P802.3ck D1.4

Common-mode comments

Matt Brown, Huawei, 802.3ck Editor-in-Chief

Figure 162–5—Differential to common-mode cable assembly return loss

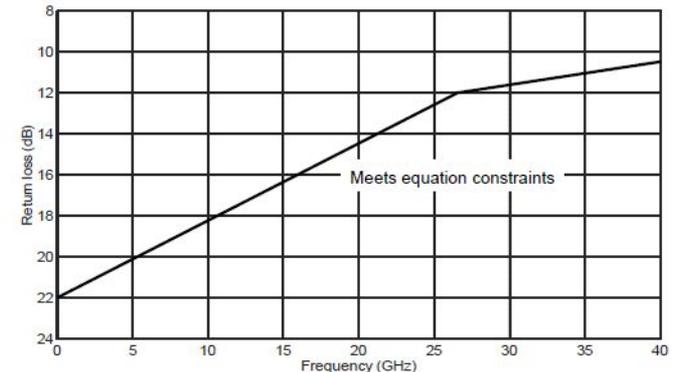
CI 162	SC 162.11.4	P 165	L 8	# 101
Champion, Bruce		TE Connectivity		
Comment Type	T	Comment Status	D	CA RLCD
Cable Assembly Diff-to-Common Mode Return loss is too tight for high volume production testing at the higher frequencies. Failures are occurring because of testing artifacts and not because of poor cable assemblies. A slight relaxation of the limit is requested to account for this.				
<i>Suggested Remedy</i>				
It is recommended to use the following equation for this limit:				
Return Loss(f) ≥ 22-10(f/26.56) for 0.05 ≤ f < 26.56				
Return Loss(f) ≥ 19 - 7(f/26.56) for 26.56 ≤ f ≤ 40 GHz				
See presentation				
<i>Proposed Response</i>		<i>Response Status</i> W		
PROPOSED ACCEPT IN PRINCIPLE.				
Implement suggested remedy.				
Pending review of cited presentation.				
https://www.ieee802.org/3/ck/public/21_01/champion_3ck_02_0121.pdf
